Serial Number 2692

Subject: License Amendment Application to Increase Allowable Power  
(License Amendment Request No. 00-0006)

Proposed Modifications to the Davis-Besse Nuclear Power Station (DBNPS) Unit Number 1, Facility Operating License NPF-3, Including the Appendix A Technical Specifications, to Allow a Power Uprate and to Revise Departure From Nucleate Boiling Parameters.

Figure 2.1-1 Reactor Core Safety Limit

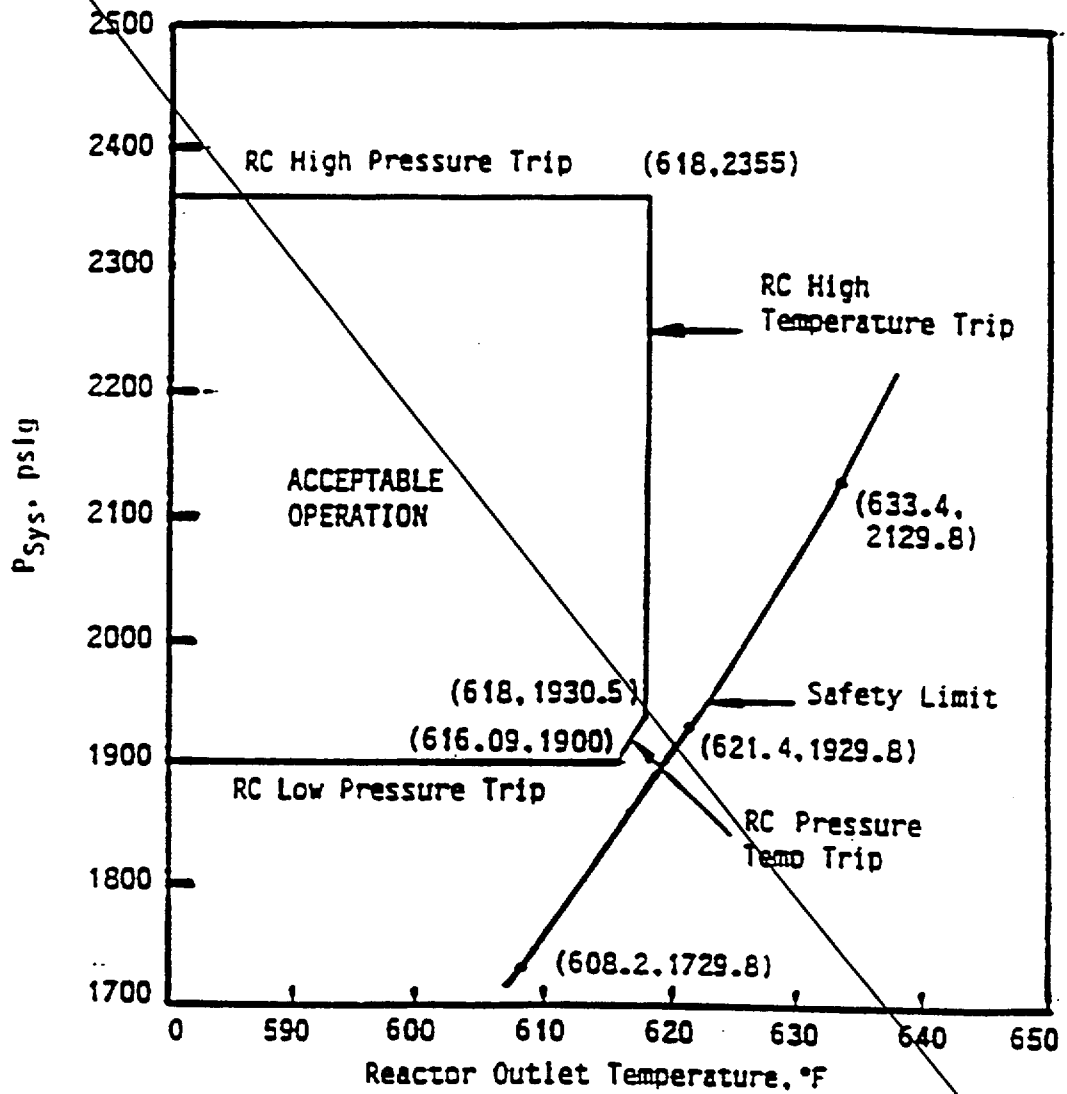
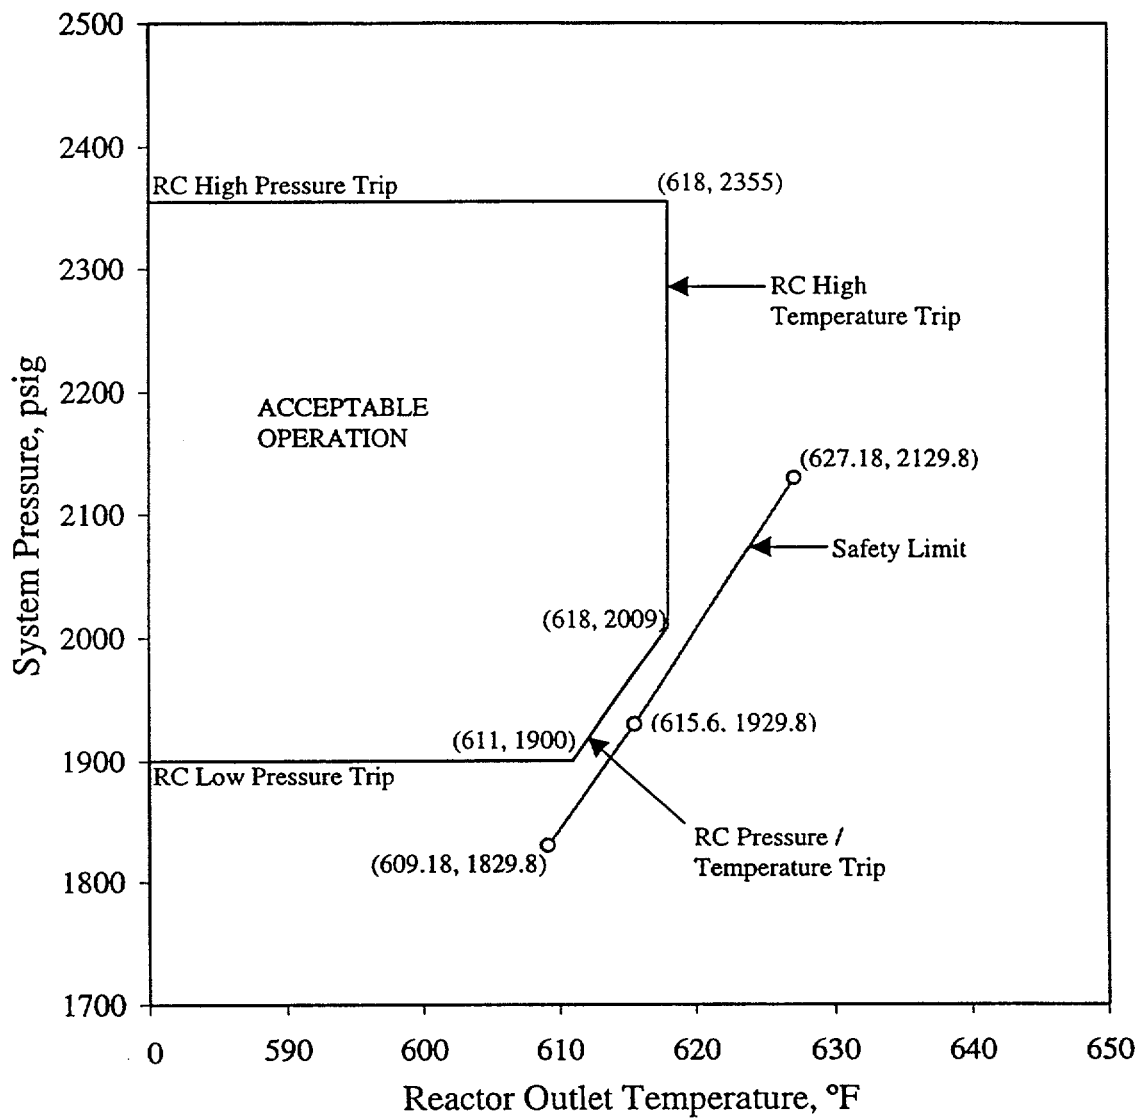
TS 2.1.1 states that the combination of reactor coolant outlet pressure and outlet temperature shall not exceed the safety limit shown in Figure 2.1-1, Reactor Core Safety Limit. It is proposed to revise Figure 2.1-1 to reflect updated data as a result of the proposed power uprate. Related changes to the associated TS Bases are also proposed, including a revised Bases Figure 2.1, Pressure/Temperature Limits at Maximum Allowable Power for Minimum DNBR.

The proposed revision to TS Figure 2.1-1 is in accordance with updated analyses in support of the proposed power uprate, as described in Reference 3. These analyses showed that more restrictive reactor core safety limits were appropriate. Based on the Reference 3 evaluation, this proposed change will have no adverse effect on nuclear safety.

Replace with  
new Figure  
(next page)

Bases Figure 2.1 Pressure/Temperature Limits at Maximum Allowable Power for Minimum DNBR

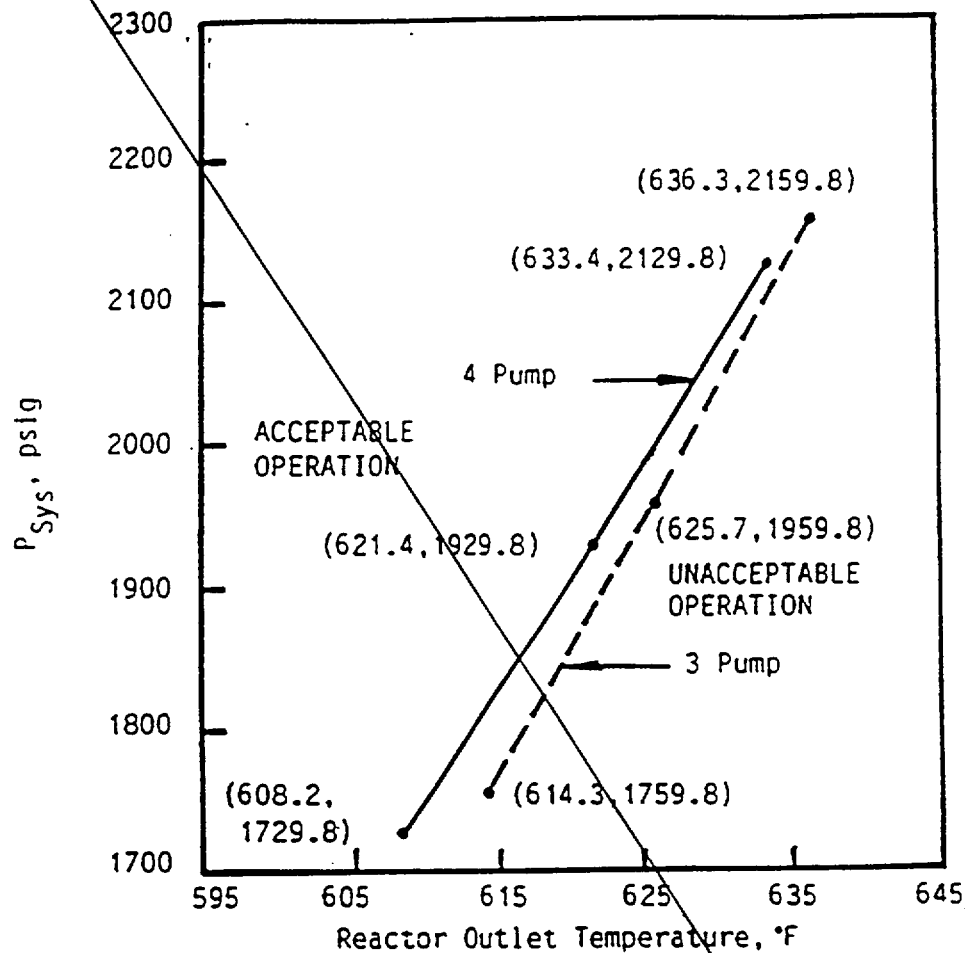
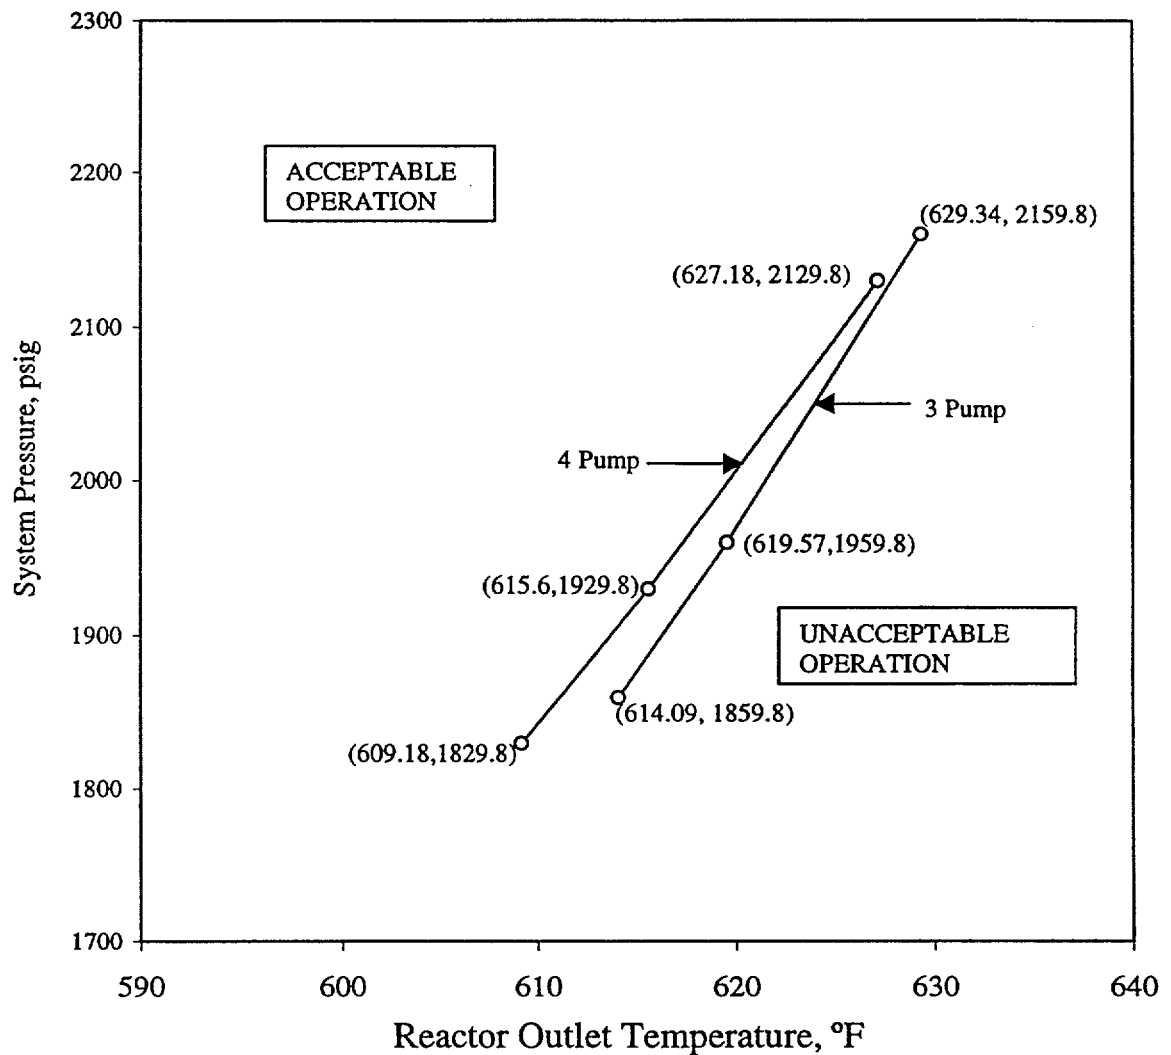
The proposed changes to the associated TS Bases, including a revised Bases Figure 2.1 are related to the above changes, and, as such, are administrative changes that will have no adverse effect on nuclear safety. These changes are supported by the reviews and evaluations described in Reference 3, and reflect the use of the Framatome ANP evaluation method for Statistical Core Design, BAW-10187P-A (Reference 8), that is the basis for the power uprate program DNBR safety evaluations.

<u>Pumps</u>	<u>Flow, gpm</u>	<u>Power</u>	<u>Required Measured Flow to ensure Compliance, gpm</u>
4	380,000	110.2 %	389,500
3	283,860	89 %	290,957

Replace with  
new Figure  
(next page)

Reactor Coolant System Pressure-Temperature Limits  
For Heatup and Core Criticality for the First ~~20~~ 21 EFY

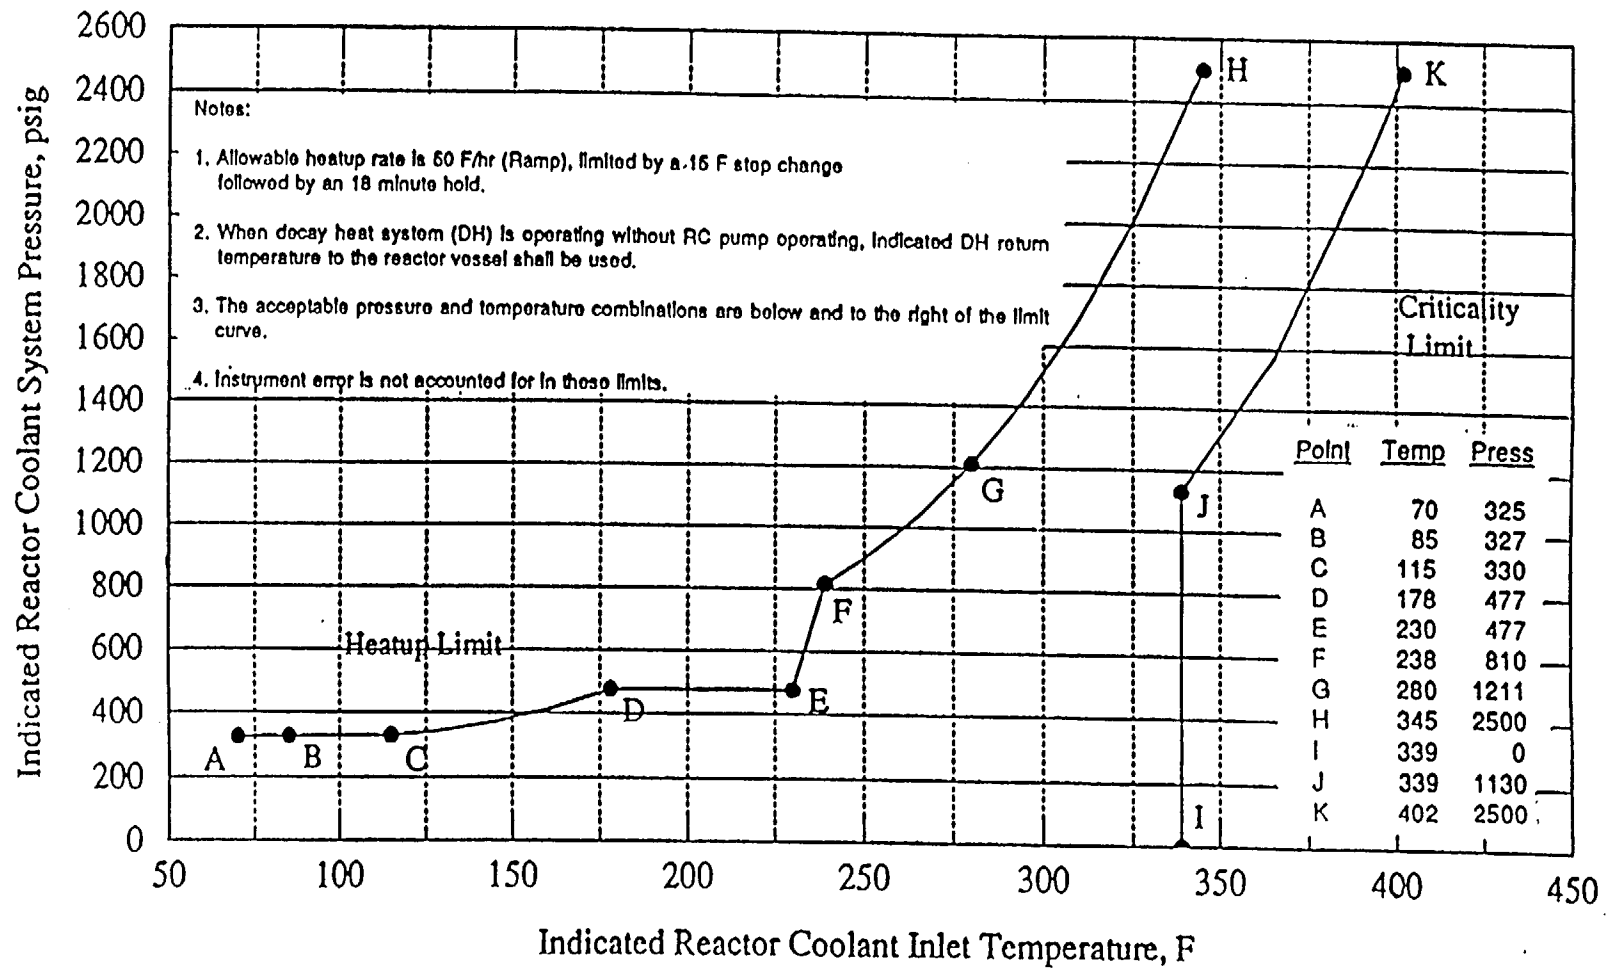
The titles of TS Figures 3.4-2, 3.4-3, and 3.4-4 presently state that they apply for the first 21 Effective Full Power Years (EFPY) of operation. As a result of the proposed power uprate, it is proposed to revise the titles to reflect that these figures now apply to the first 20 EFPY of operation.

The proposed revisions to the titles of TS Figures 3.4-2, 3.4-3, and 3.4-4 is in accordance with updated analyses in support of the proposed power uprate, as described in Reference 3. These analyses showed that due to the power uprate, the pressure/temperature limit curves shown in the figures are now only applicable to the first 20 Effective Full Power Years (EFPY) of operation, rather than the current 21 EFPY. This change continues to ensure that the Reactor Coolant System pressure/temperature limits will be appropriately maintained and, accordingly, this change will have no adverse effect on nuclear safety.
